## Adapter Plate Improvements - 3.0 Litre V6

1994 thru 1996, 3.0 Litre V6  
S/N 0D280813 thru 0G437999

a - Crack In Exhaust Adapter Plate

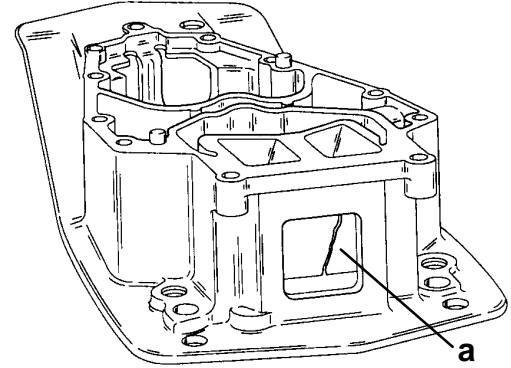
If condition 1 is suspected, inspect the idle exhaust boot for a charred or burned appearance. If burned, remove exhaust boot from the adapter plate and inspect for a crack in the adapter plate.

- a - Bottom View Driveshaft Housing
- b - Water Discharge Holes
- c - Exhaust Tube

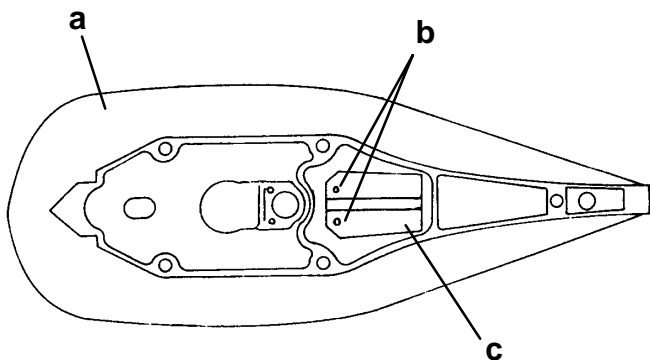
Plugged water discharge holes in adapter plate. This condition should be suspected when the customer reports repeated failures of the propeller hub within a short period of time, or if the bearing carrier seals look charred or burned.

The exhaust gases that exit the engine are cooled by water that enters the exhaust system at the adapter plate. If condition 2 is suspected it is likely that the water discharge holes are blocked with debris. To inspect discharge holes first remove the lower unit. Then using a light, look up the exhaust tube. If the two discharge holes are blocked they must be cleared. In most cases it is not necessary to remove the powerhead to clear the discharge holes.

Exhaust system water discharge holes in most cases can be cleared by using a # 39 (2.5mm) drill bit on the end of a 2 ft. long 3/8" dia. iron rod. A hole can be drilled into the end of the rod using a #39 drill bit. Then install the #39 drill bit into the hole drilled in the rod. Drill bit can be retained into rod by brazing or with a set screw. Using the rod/drill bit assembly go up through the exhaust tube and clear out debris from discharge holes. Then flush out the cooling system as outlined in the Operation and Maintenance Manual. Regular flushing of the cooling system will help keep the discharge holes clear.
